Non-Attainment Area Management Plan

Site 6277
San Leandro, California

Key revision:

① proposal for
additional well
down gradient of
mw-1

PETROLEUM HYDROCARBON CONCENTRATIONS IN GROUND WATER ON JULY 7, 1994

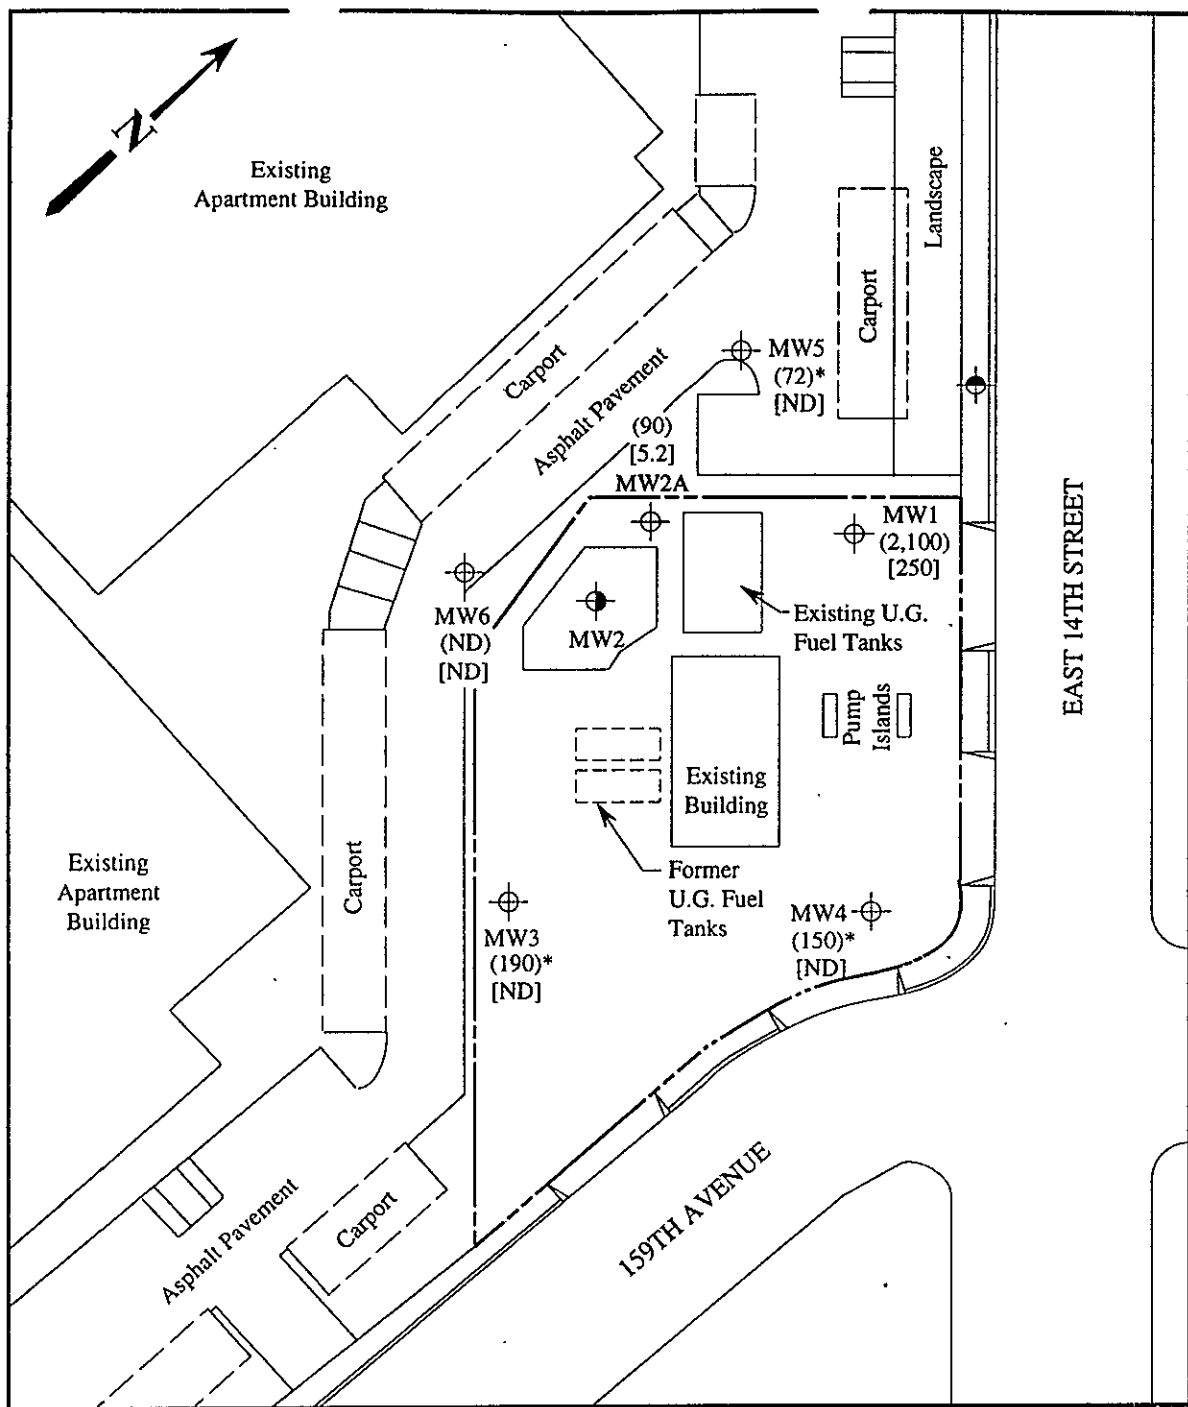
Show location of former waste oil tank. (removed in 1989)
